# ROADWAY AND STORM SEWER CONSTRUCTION PLANS FALCON MEADOWS AT BENT GRASS FILING NO. 4 FALCON, CO 80831 - EL PASO COUNTY CHALLENGER COMMUNITIES, LLC

PCD-ENGINEERING REVIEW COMMENTS IN BLUE BOXES WITH BLUE TEXT

> **Engineering Review** 08/19/2022 2:52:28 PM dsdrice JeffRice@elpasoco.com (719) 520-7877 **EPC Planning & Community Development Department**

# Construction Drawings (PlansProfiles)\_v1.pdf Markup Summary 8-29-2022

OVERALL SHEET

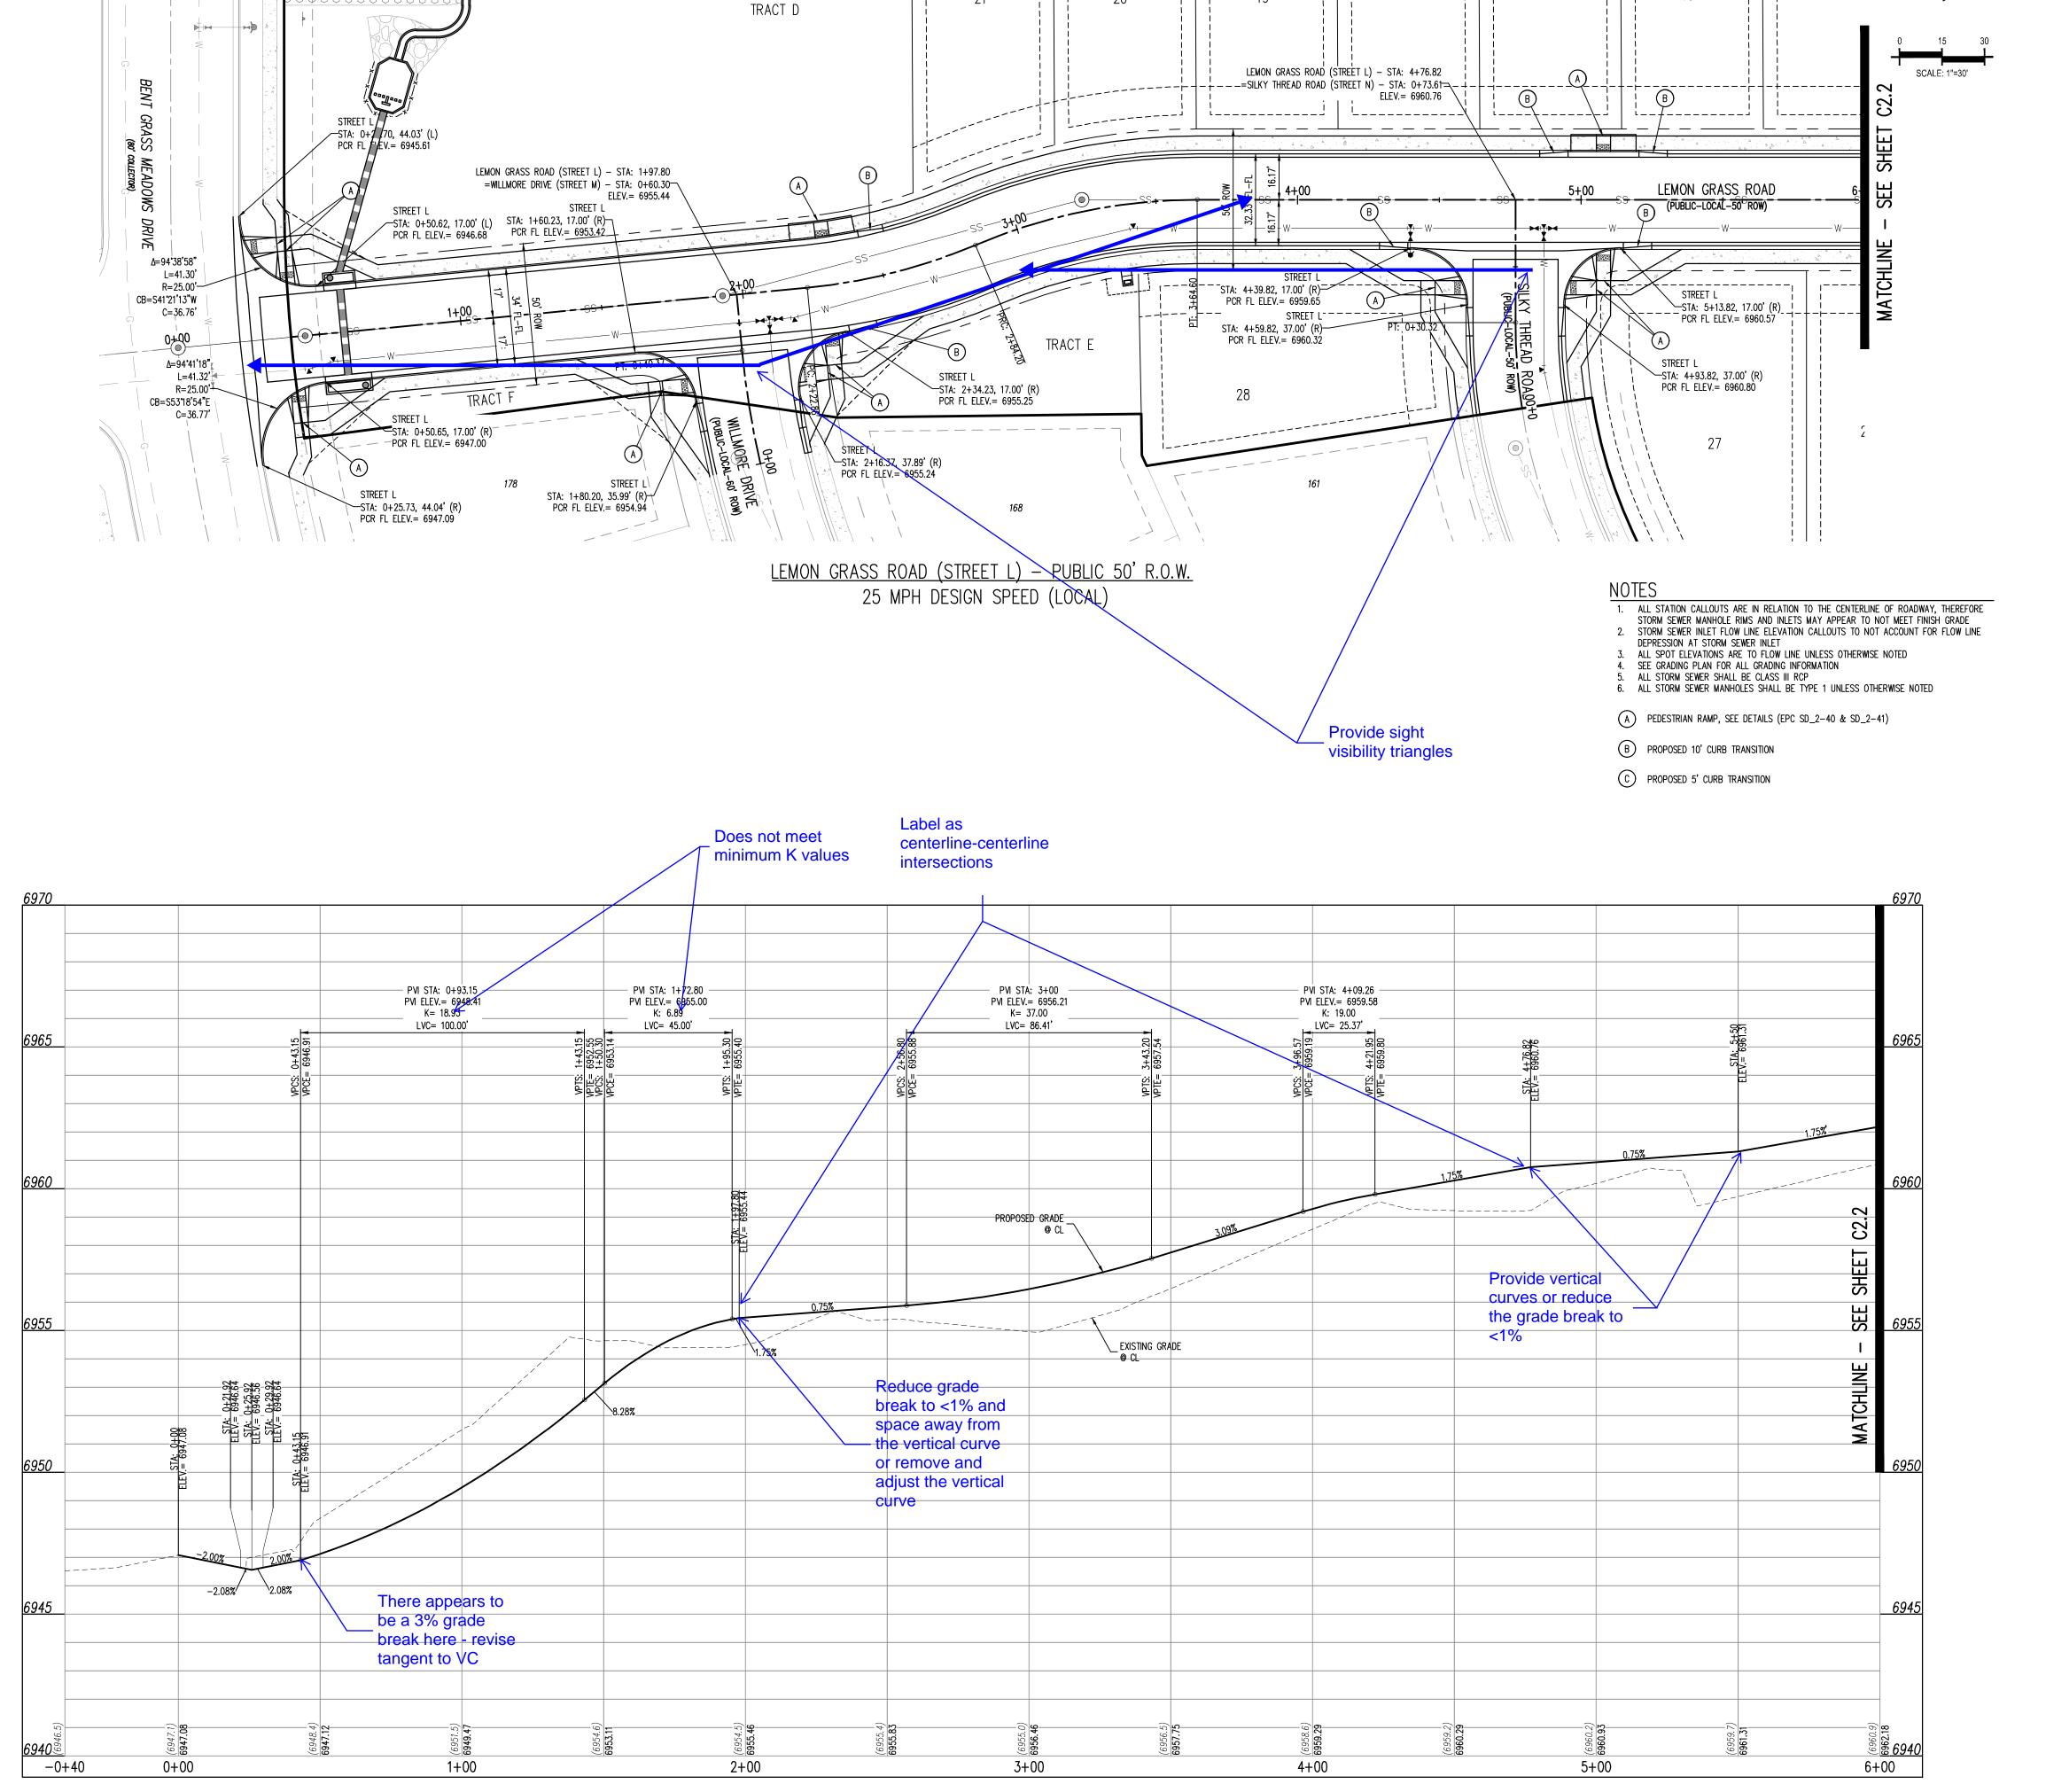
Add the applicable street names

Adjust/add tracts per other comments

IMPROVEMENT PLAN

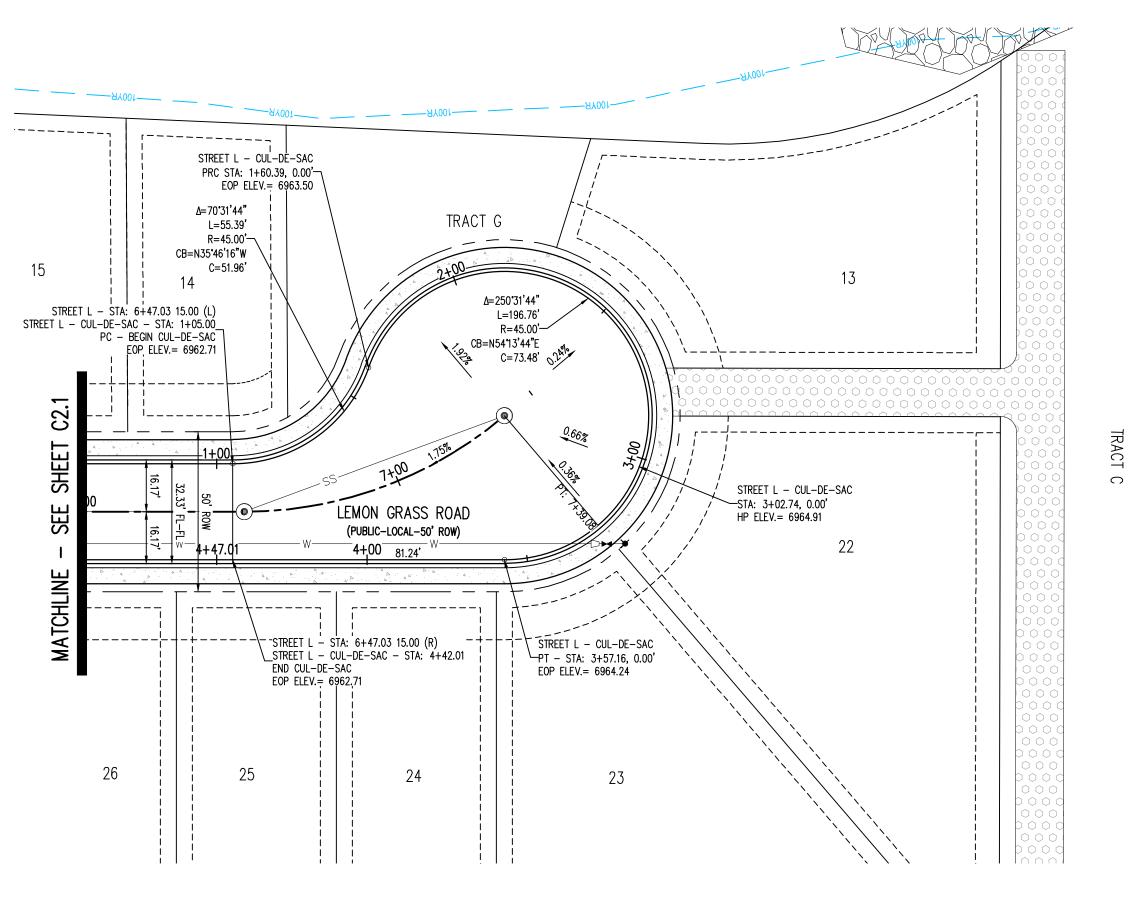
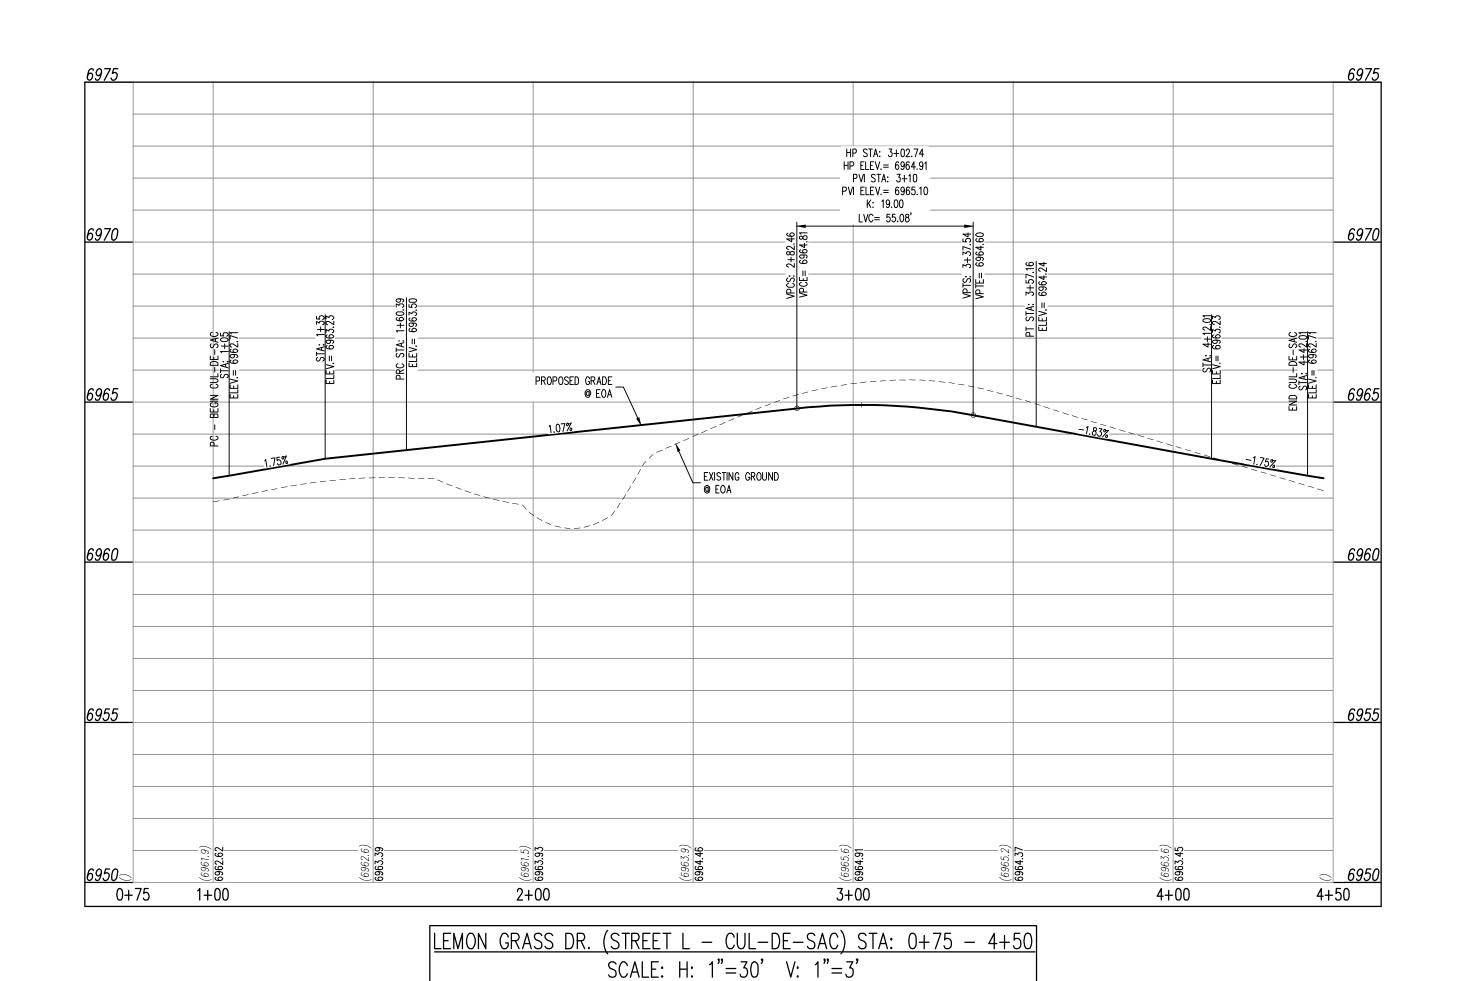
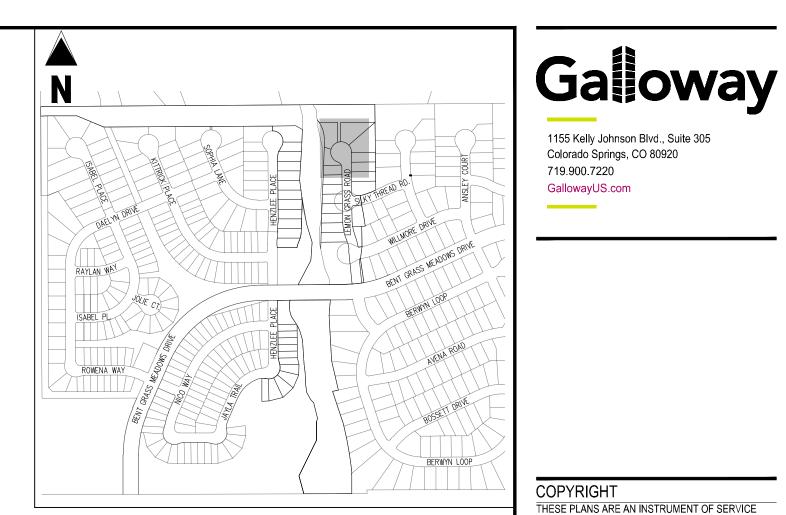
Page Label: [5] 5 LEMON GRASS RD IMPROVEMENT PLAN There appears to be a 3% grade break here -

Reduce grade break to <1% and space away from the vertical curve or remove and adjust the vertical

revise tangent to VC

Page Label: [5] 5 LEMON GRASS RD IMPROVEMENT PLAN Provide vertical curves or reduce the grade break

Page Label: [5] 5 LEMON GRASS RD IMPROVEMENT PLAN Does not meet minimum K values

Page Label: [5] 5 LEMON GRASS RD IMPROVEMENT PLAN Provide sight visibility triangles

Page Label: [5] 5 LEMON GRASS RD IMPROVEMENT PLAN Label as centerline-centerline intersections

**PLANS**

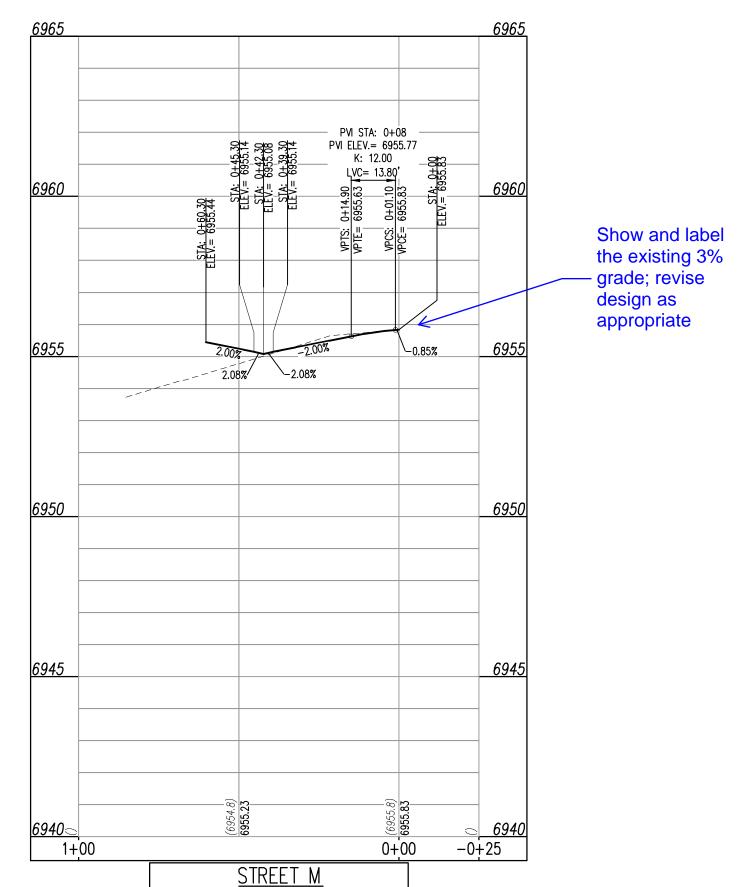
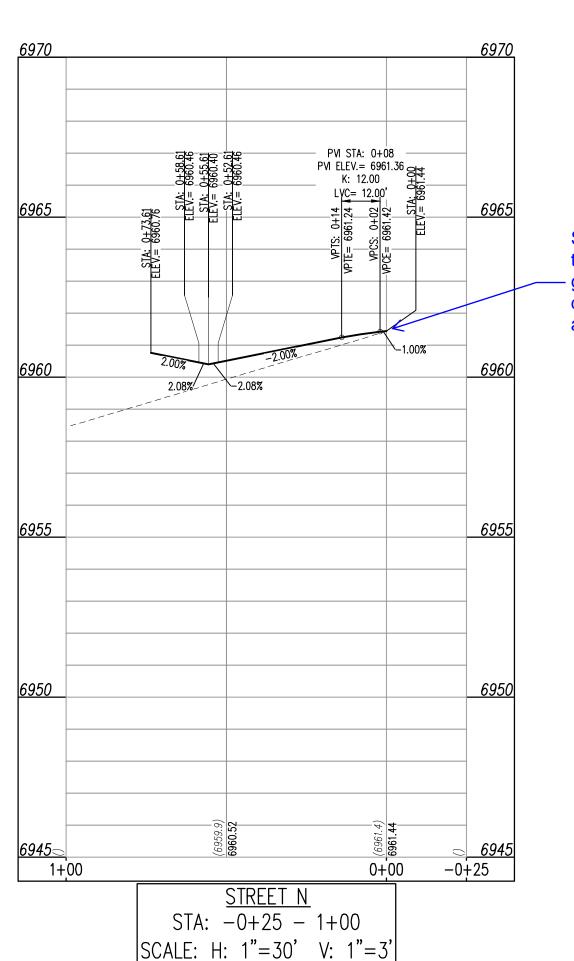
Show and label the existing 3% grade; revise design as appropriate

Show and label the existing 3% grade; revise

Show and label the existing 3% grade; revise
